# HISTORIC AND DESIGN REVIEW COMMISSION

**HDRC CASE NO:** 2025-006  
**ADDRESS:** 511 E DEWEY PLACE  
**LEGAL DESCRIPTION:** NCB 2964 BLK 3 LOT 3 W 12 FT OF 4  
**ZONING:** MF-33, H  
**CITY COUNCIL DIST.:** 1  
**DISTRICT:** Tobin Hill Historic District  
**APPLICANT:** Victor Hinojosa/Cognition Creative LLC  
**OWNER:** EDWARD & MICHELLE LUPOMECH/LUPOMECH MICHELLE & EDWARD  
**TYPE OF WORK:** Construction of a rear accessory structure  
**APPLICATION RECEIVED:** January 08, 2025  
**60-DAY REVIEW:** March 10, 2025  
**CASE MANAGER:** Caitlin Brown-Clancy

The applicant is requesting a Certificate of Appropriateness for approval to construct a 647 sf enclosed garage with an attached patio at the rear of the property.

SHEET TITLE  
ELEVATIONS

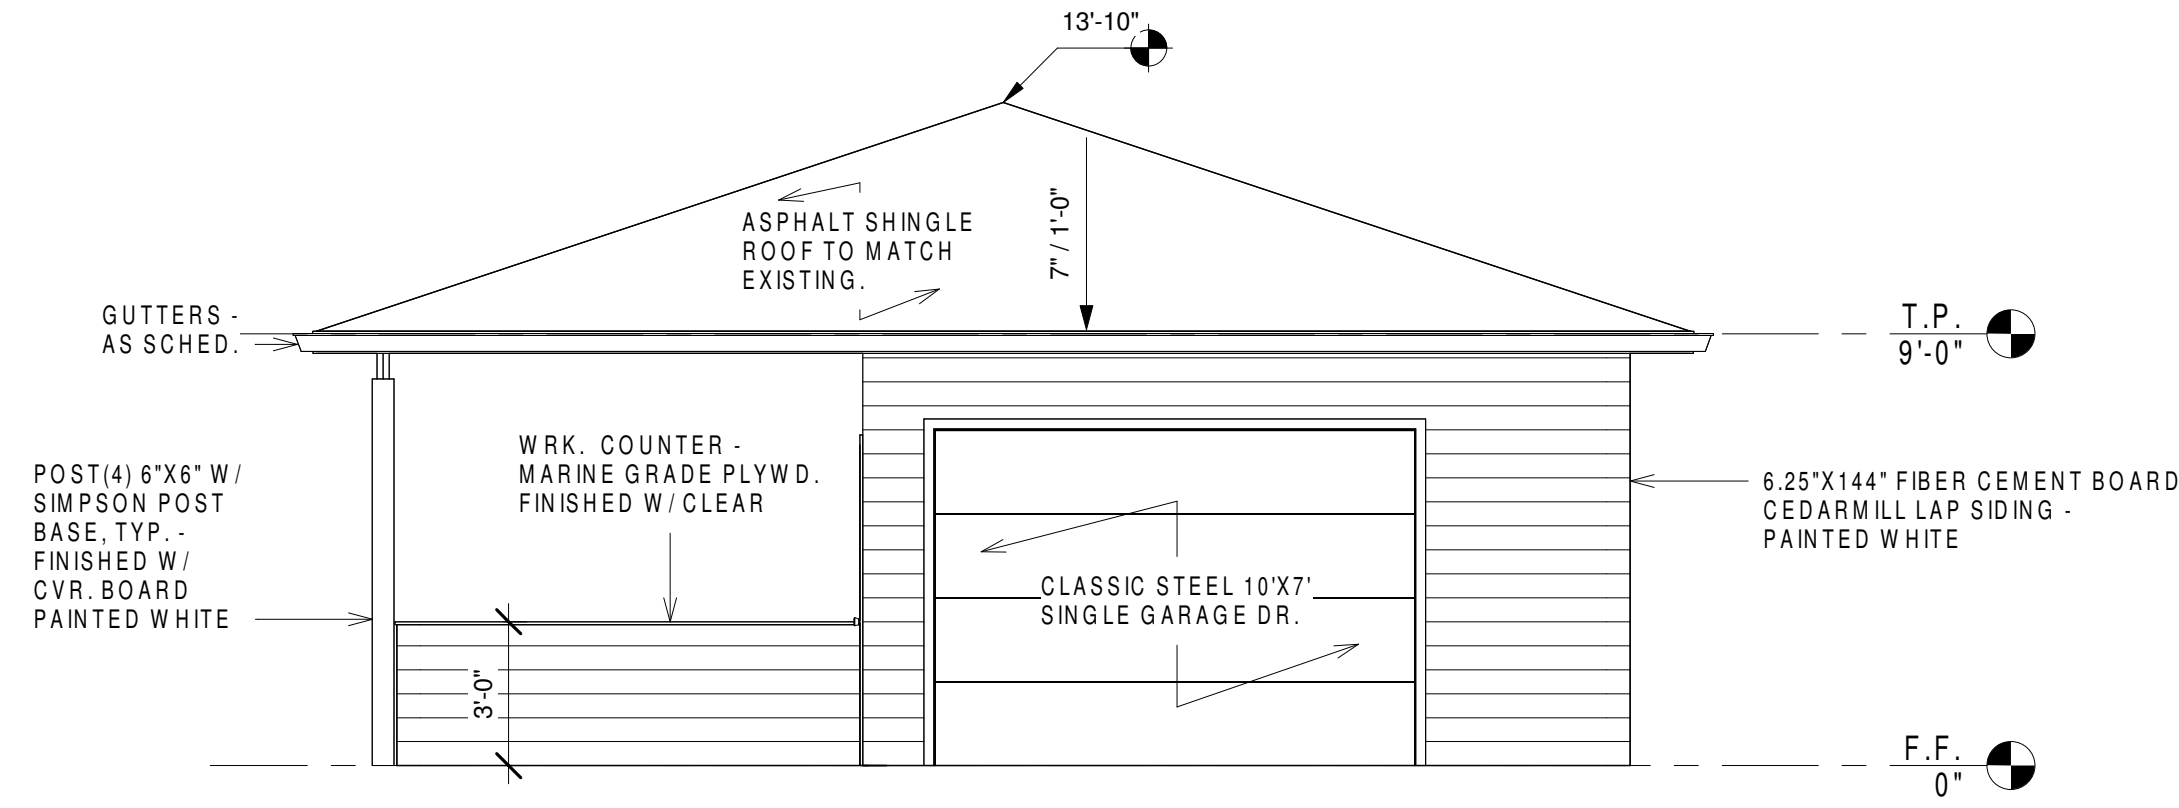
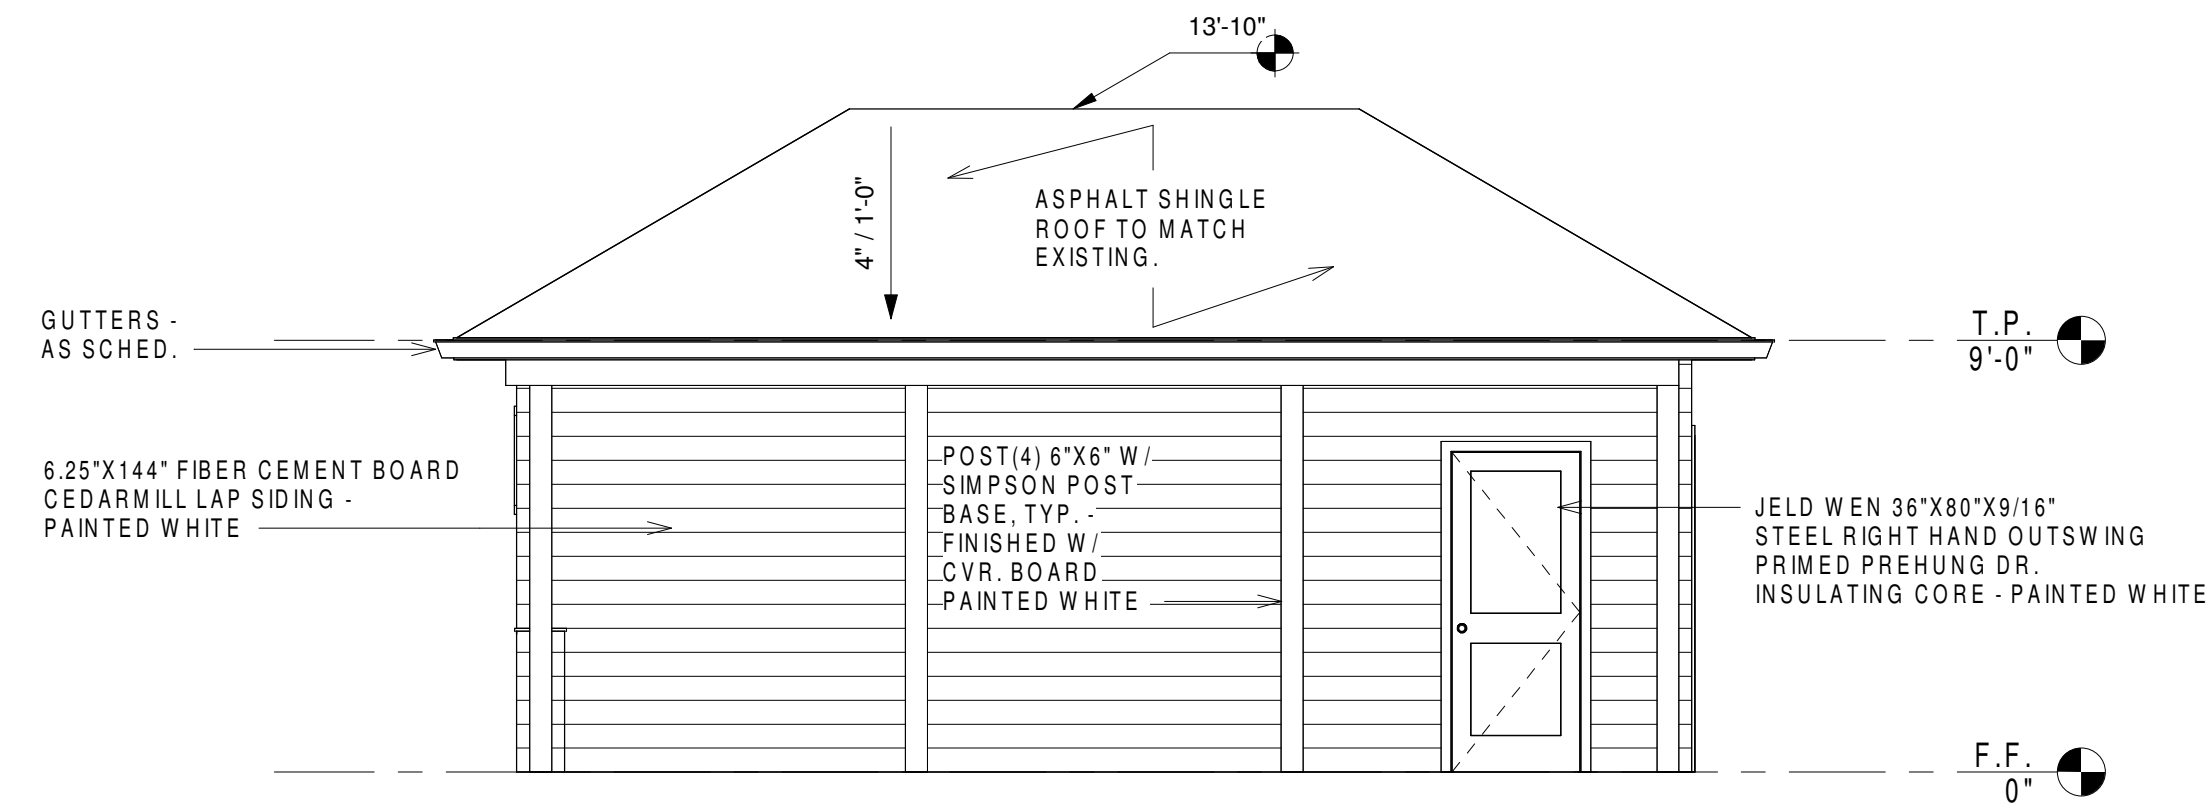
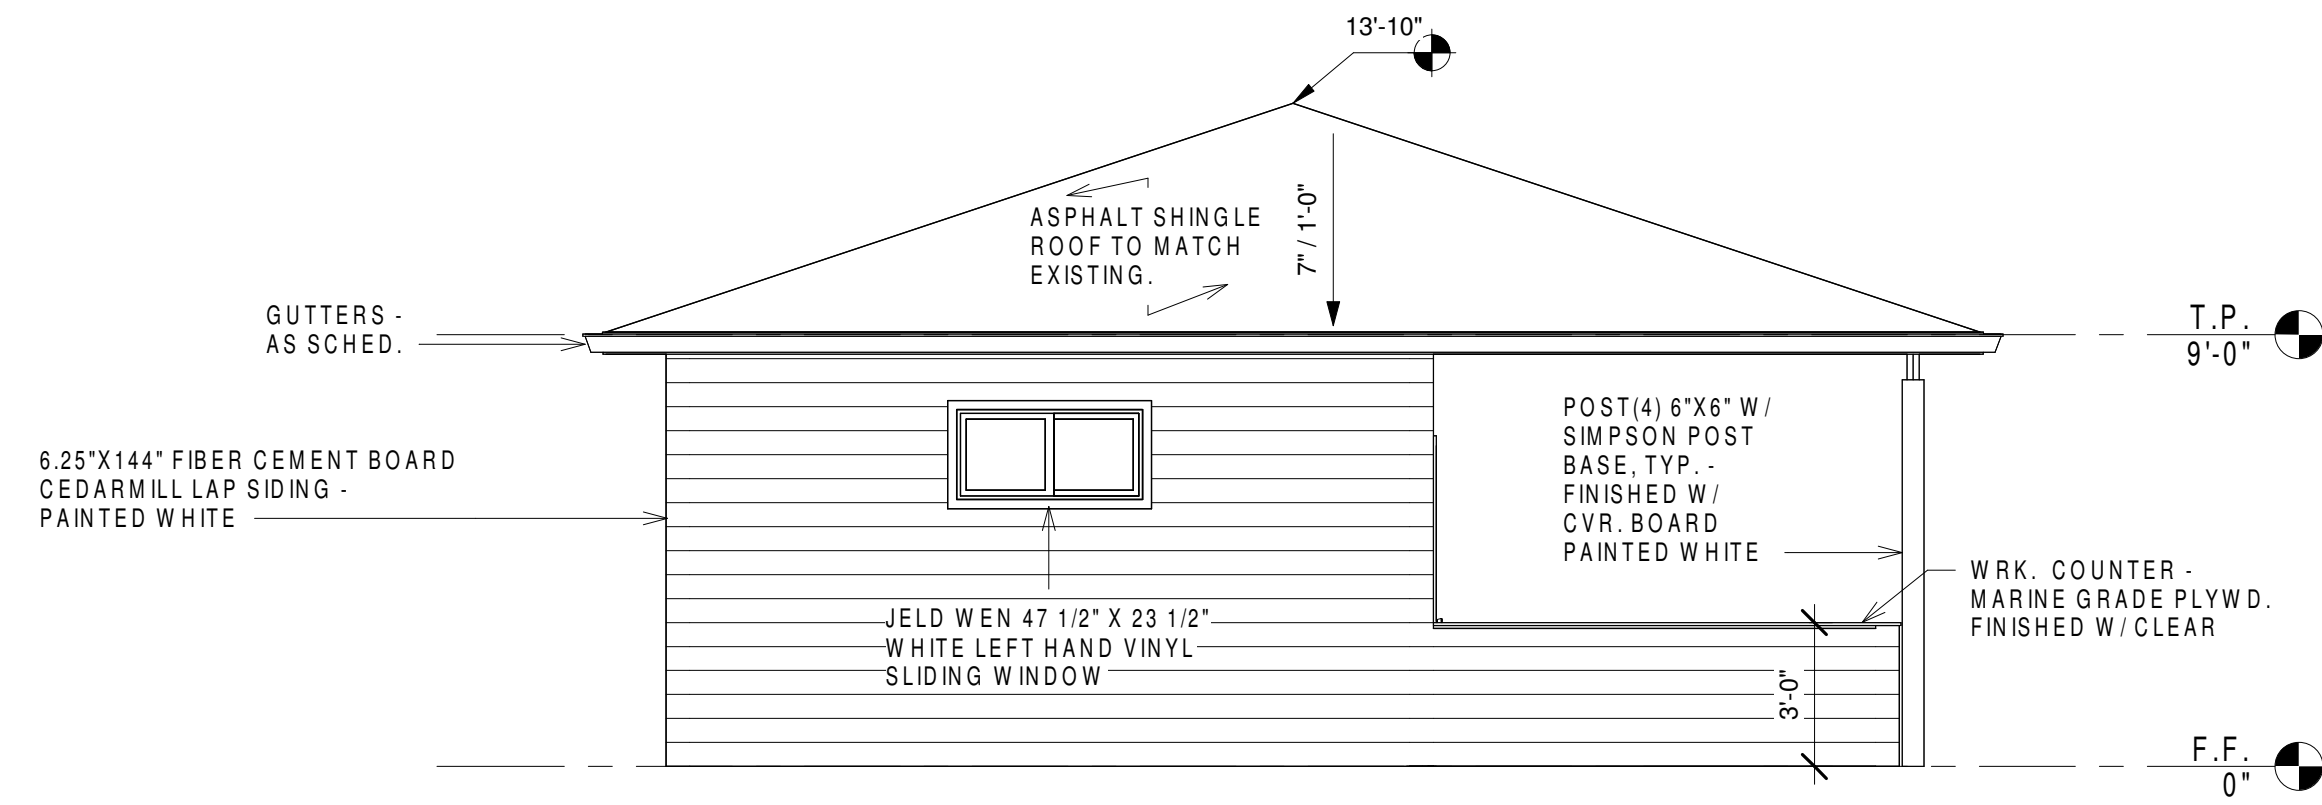
- b. ROOF FORM - The applicant has proposed to install a hip roof on the garage. The Guidelines for New Construction 5.A.iii. and iv. note that new accessory structures should relate to the period of construction of the primary historic structure on the lot by using complementary materials and simplified architectural details. Guideline 2.B.i states that roof forms—pitch, overhangs, and orientation—consistent with those predominately found on the block should be incorporated. The primary structure features a hipped roof and historic structures in the context area feature hipped, front gable, side gable, and cross gable roof forms. Staff finds the proposed roof form consistent with the guidelines.

- c. MATERIALS & TEXTURE – The applicant is requesting to construct a 647 sf enclosed garage with attached porch at the NW (rear) corner of the property featuring an asphalt shingle roof to match that of the primary structure, fiber cement siding, and wooden columns. Guideline 3.a.i states that materials that complement the type, color, and texture of materials traditionally found in the district should be used. Fiber cement siding must

feature a reveal of no more than 6” and a smooth texture facing outward. Staff finds the proposed materials appropriate, however, finds that applicant should submit detailed material specifications and siding exposure details prior to issuance of a COA.

- f. **DOORS & WINDOWS** – The applicant is proposing a sliding vinyl window on the Western elevation, a painted steel exterior door and a steel garage door. The Guidelines for New Construction 5 a.iv and 5.a.v, states that window and door openings to be similar to those found on historic garages or outbuildings in the district or on the principle historic structure in terms of their spacing and proportions. Additionally, garage doors with similar proportions and materials as those found traditionally in the district should be incorporated in new construction. Staff finds the proposed window inconsistent with the Standard Specifications for Windows in New Construction. Additionally, staff finds the applicant should submit all product specifications prior to issuance of a COA.

1. That the applicant submit all material and installation specifications to include siding and siding exposure details and roofing products to staff for review prior to the issuance of a COA as noted in finding c.
2. That the applicant propose a window product that conforms to the Standard Specifications for Windows in New Construction and that the applicant submits all product specifications to include the window, exterior door, and garage door to staff for review prior to the issuance of a COA as noted in finding f.
